ATTACHMENT 1

Marked Up Technical Specifications Pages

SAFETY EVALUATION

This amendment request is in support of Callaway Refuel 8. During Refuel 8, fuel that does not meet the current IFBA versus enrichment limit of FSAR Figure 9.1A-4 and Technical Specification 5.3.1 is planned to be loaded into the core. This amendment request proposes to modify Technical Specification section 5.3.1 to reflect a change in the maximum initial enrichment to 5.0 w/o U-235 for reload fuel and a change to the maximum fuel enrichment without requiring integral fuel burnable absorbers (IFBAs) for storage in Region 1. We also request that Technical Specification section 5.6.1.1 be revised to reflect a change in the maximum reference K_{∞} from 1.455 to 1.480 for storage in Region 1 of the Spent Fuel Pool. Technical Specification Figure 3.9-1 is also to be revised to reflect a maximum initial enrichment of 5.0 w/o for storage in Region 2.

FIGURE 3.9-1
MINIMUM REQUIRED FUEL ASSEMBLY BURNUP AS A FUNCTION
OF INITIAL ENRICHMENT TO PERMIT STORAGE IN REGION 2

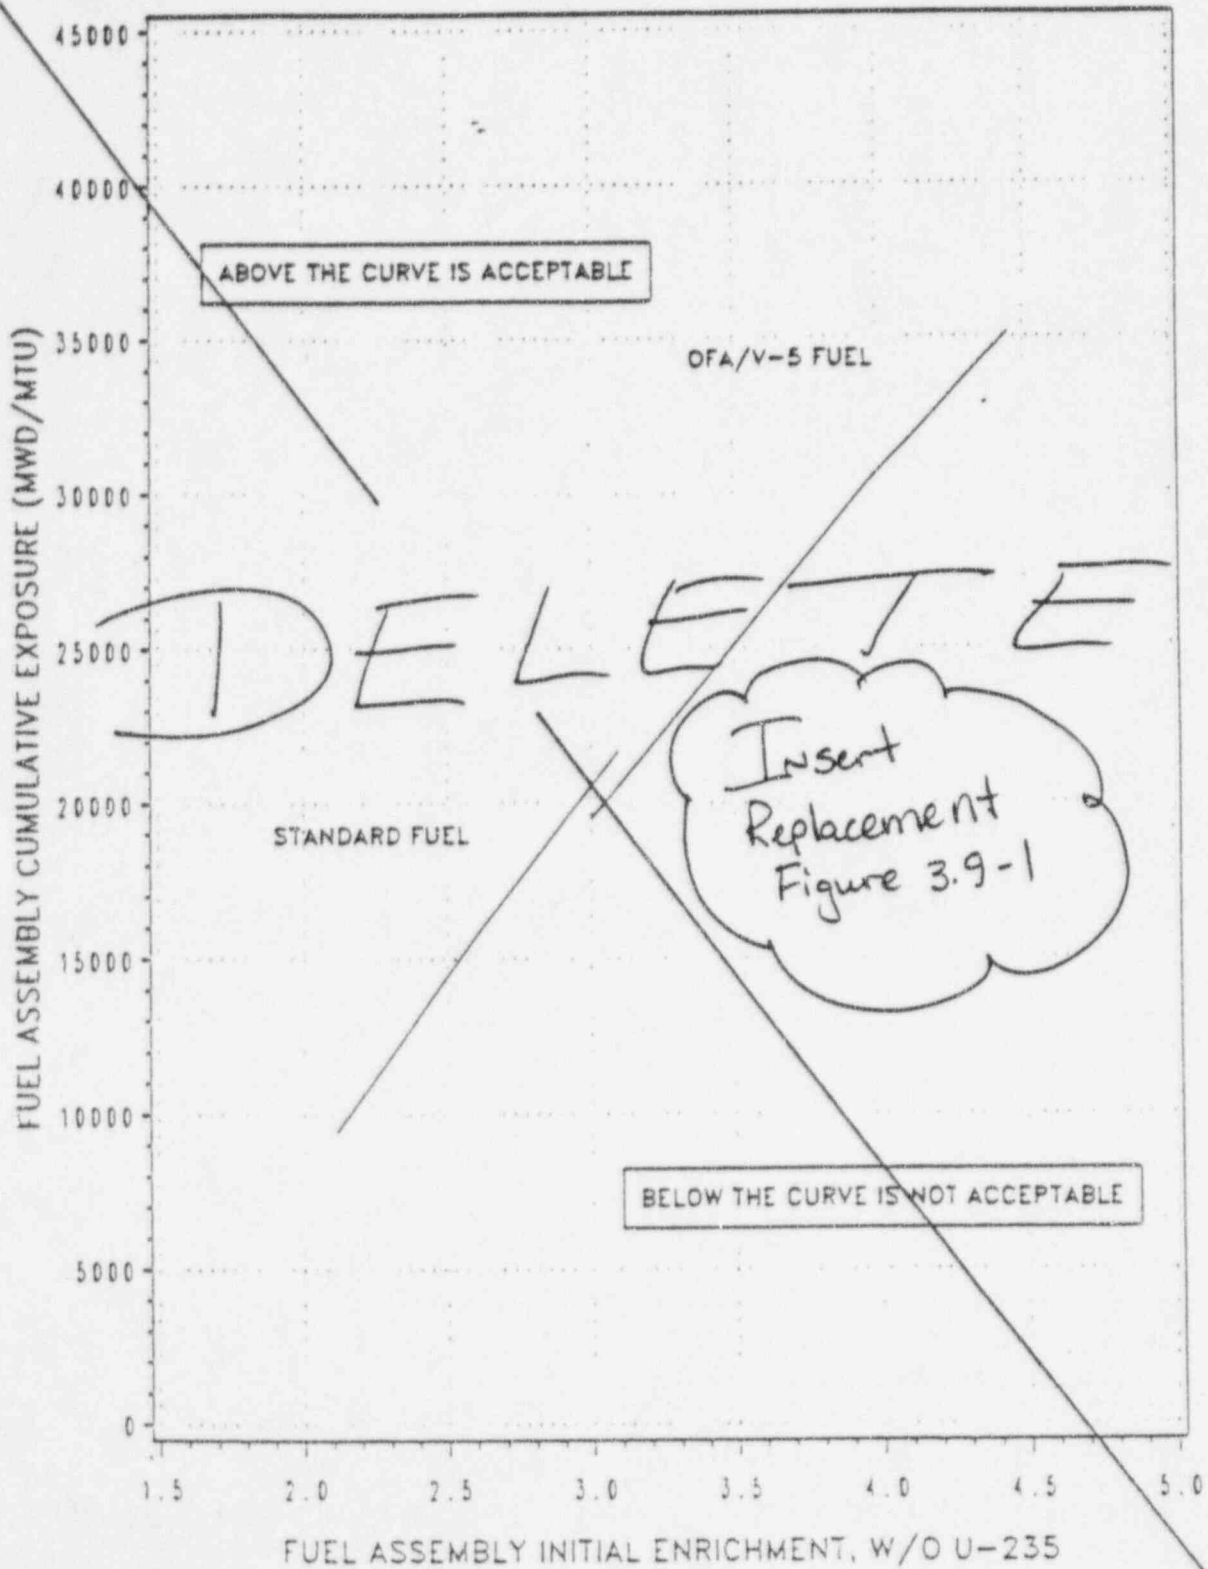
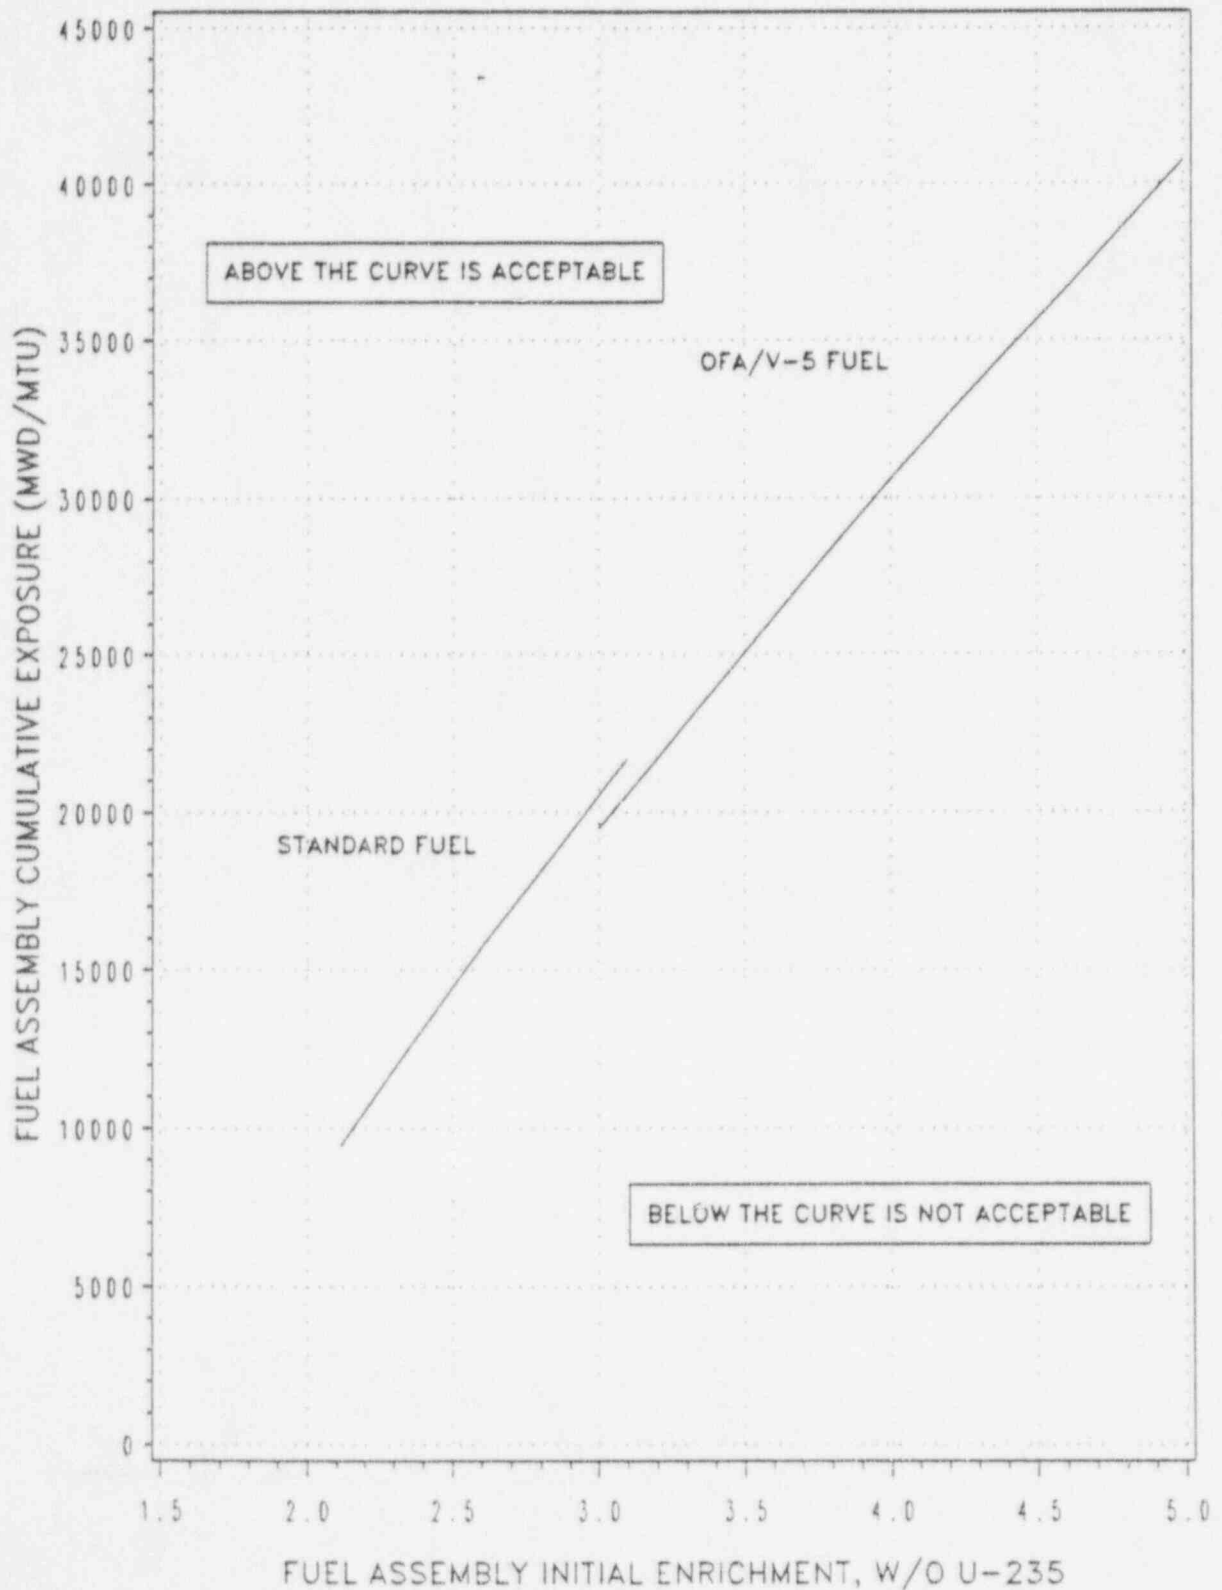
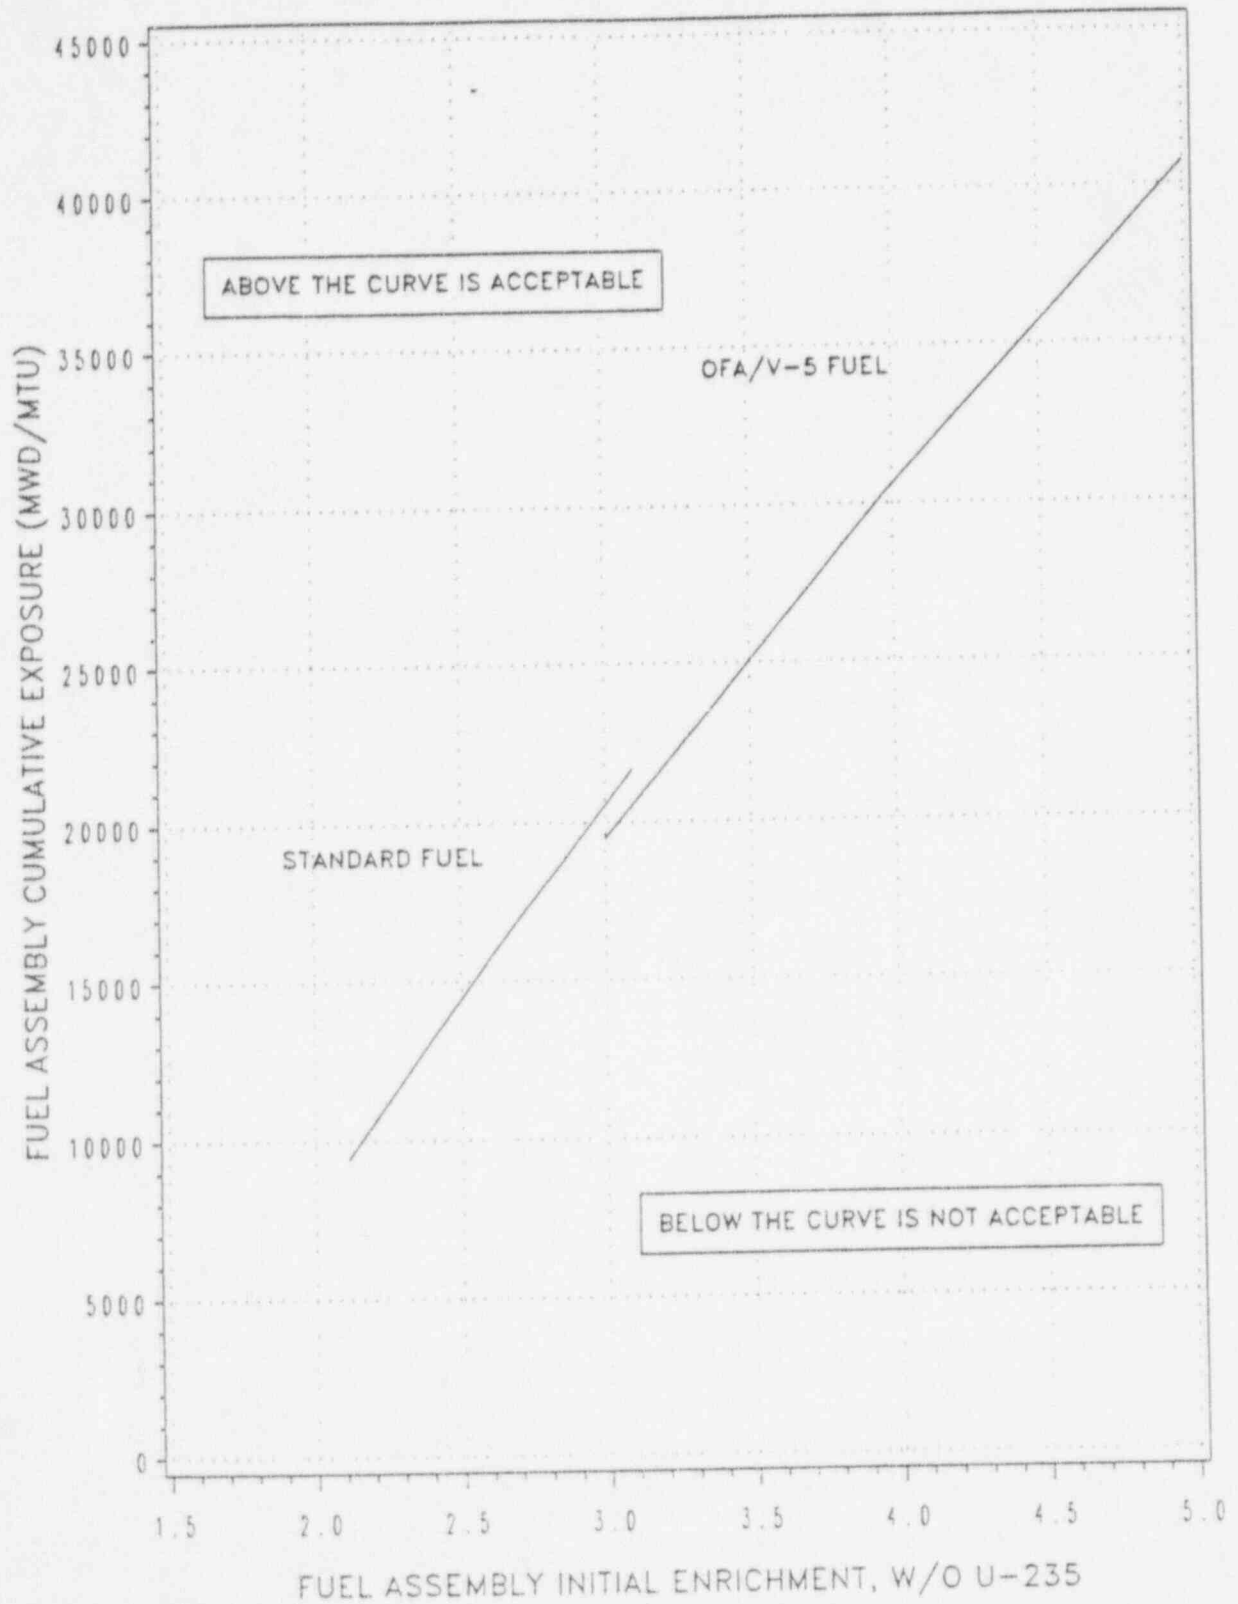
Previously approved analyses performed to support the storage of higher enrichment fuel in Region 2 of the Callaway spent fuel pool concluded that spent fuel criticality limits are maintained when storing fuel to a maximum initial enrichment of 5.0 w/o U-235, provided that the fuel burnups meet the prescribed limits (reference ULNRC-2647, dated June 12, 1992). The previous amendment only addressed fuel enrichments up to 4.45 w/o U-235 due to thermal/hydraulic constraints. These constraints have been resolved and the current spent fuel pool heat load methodology can be used to support storage of fuel up to a maximum initial enrichment of 5.0 w/o U-235. However, cycle specific decay heat load analyses will still be required.

FIGURE 3.9-1
MINIMUM REQUIRED FUEL ASSEMBLY BURNUP AS A FUNCTION
OF INITIAL ENRICHMENT TO PERMIT STORAGE IN REGION 2
